UNITED STATES PATENT AND TRADEMARK OFFICE

APPLICATION NO.	FILING DATE	FIRST NAMED INVENTOR	ATTORNEY DOCKET NO.	CONFIRMATION NO.
10/798,422	03/12/2004	Seiji Horino	Q79112	6553
23373	7590	08/22/2006	EXAMINER	
SUGHRUE MION, PLLC 2100 PENNSYLVANIA AVENUE, N.W. SUITE 800 WASHINGTON, DC 20037			ROJAS, OMAR R	
			ART UNIT	PAPER NUMBER
			2874

Office Action Summary	Application No.		Applicant(s)	
	10/798,422		HORINO ET AL.	
	Examiner		Art Unit	
	Omar Rojas		2874

DETAILED ACTION

FIG. 14

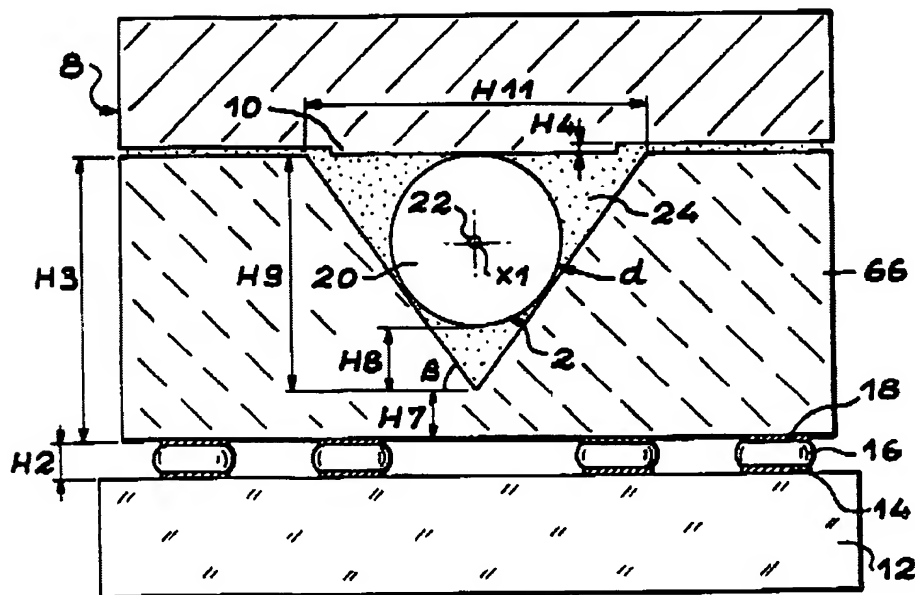
In re claim 1, Parat discloses in Figure 14, an optical fiber fixing system for fixing an optical fiber comprising:

a fixing body 66 comprising a first groove, formed in a top surface thereof, extending in a first direction to support the optical fiber 2 along its axial direction; and

a pressing body 8 comprising a protrusion 10, formed on a bottom surface thereof, and extending substantially perpendicularly to the first groove, wherein the bottom surface of the pressing body 8 faces the top surface of the fixing body 66. Figure 14 of Parat is reproduced below.

In re claim 2, the bottom surface of the pressing body 8 and the top surface of the fixing body 66 are substantially planar.

In re claim 4, the cross section of the first groove is V-shaped as seen in Figure 14.

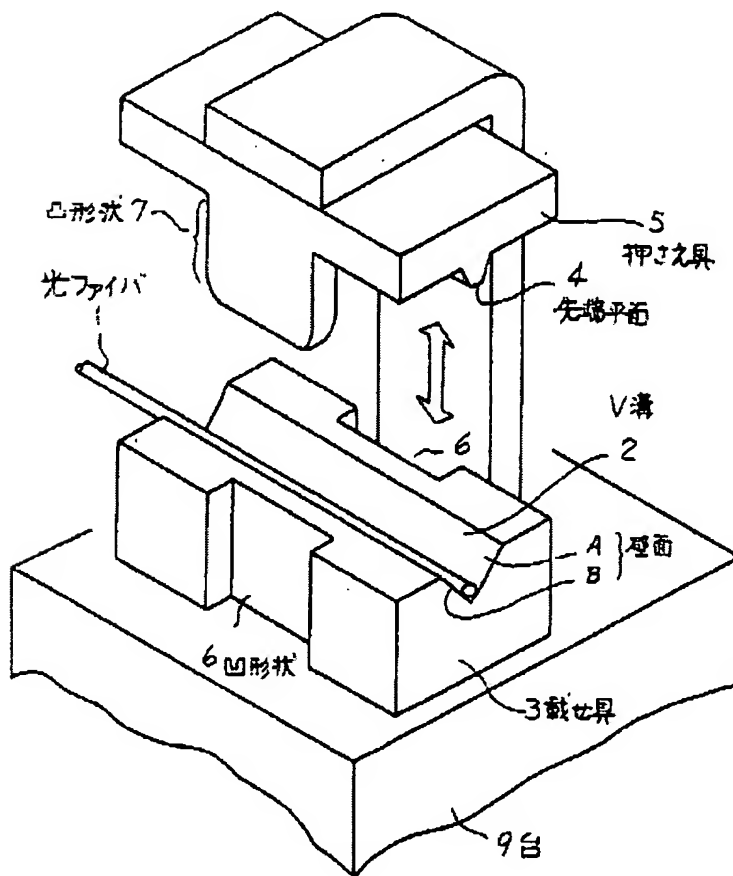
In re claim 1, Sherrer discloses in Figures 12-13, an optical fiber fixing system for fixing an optical fiber comprising:

a fixing body 322 comprising a first groove 326, formed in a top surface 324 thereof, extending in a first direction to support the optical fiber 36 along its axial direction; and

a pressing body 330 comprising a protrusion 336, formed on a bottom surface 332 thereof, and extending substantially perpendicularly to the first groove 326, wherein the bottom surface 332 of the pressing body faces the top surface 324 of the fixing body. Figure 13 of Sherrer is reproduced below.

In re claim 3, when the optical fiber 36 is supported in the first groove 326, a ridgeline of the optical fiber 36 protrudes out of the first groove above the top surface 324 of the fixing body 322.

In re claim 4, the cross section of the first groove 326 is inherently V-shaped because a V-shape is considered a well-known conventional shape to use in order to hold optical fibers.

In re claim 18, the protrusion 336 is arranged in a precision mounting groove 334 formed in the bottom surface 332 of the pressing body 330. The protrusion 336 is inherently formed of a material different from that of the pressing body 330 because there are only two possible alternatives (i.e., they are either formed of the same material or a different material).

Figure 3 of the application is reproduced below.

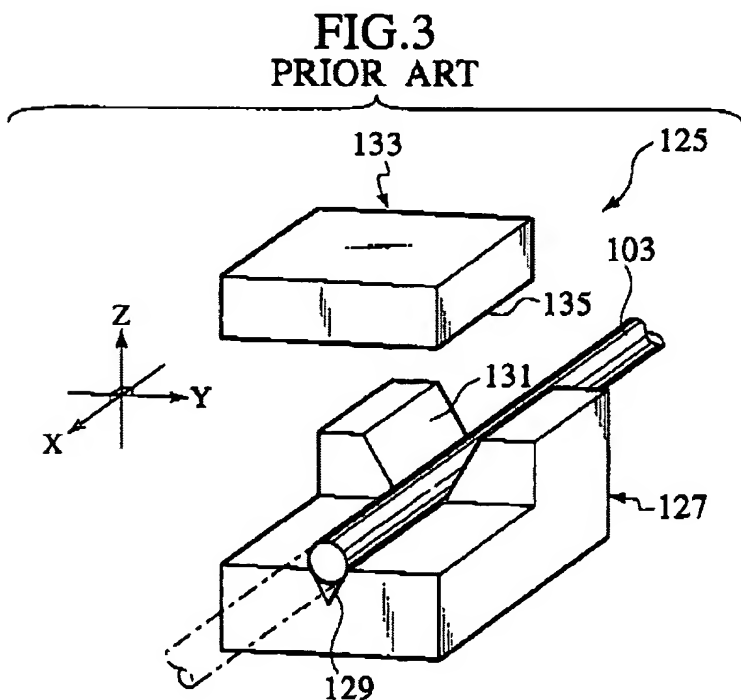
Thus, Parat and Parat in view of Tamekuni only differ from claims 3, 6-8, 10-11, and 46 in that neither reference teaches a fixing body having a stepped structure with a second groove formed in a second surface of the fixing body so that when the optical fiber is supported in the second groove the ridgeline of the fiber is above the first surface and below the second surface as recited by claims 3, 6, and 8. APA, as seen in Figure 3 of the application drawings, discloses a fixing body 127 having a stepped structure with a second groove 131 formed in a second surface of the fixing body so that when the optical fiber 103 is supported in the second groove the ridgeline of the fiber is above a first surface and below a second surface as recited by claims 3, 6, and 8.

The motivation for combining APA with Parat and Parat in view of Tamekuni is to restrict movement of the optical fiber in a Y-axis direction. Therefore, it would have been obvious to one of ordinary skill in the art at time of the claimed invention to obtain the invention specified
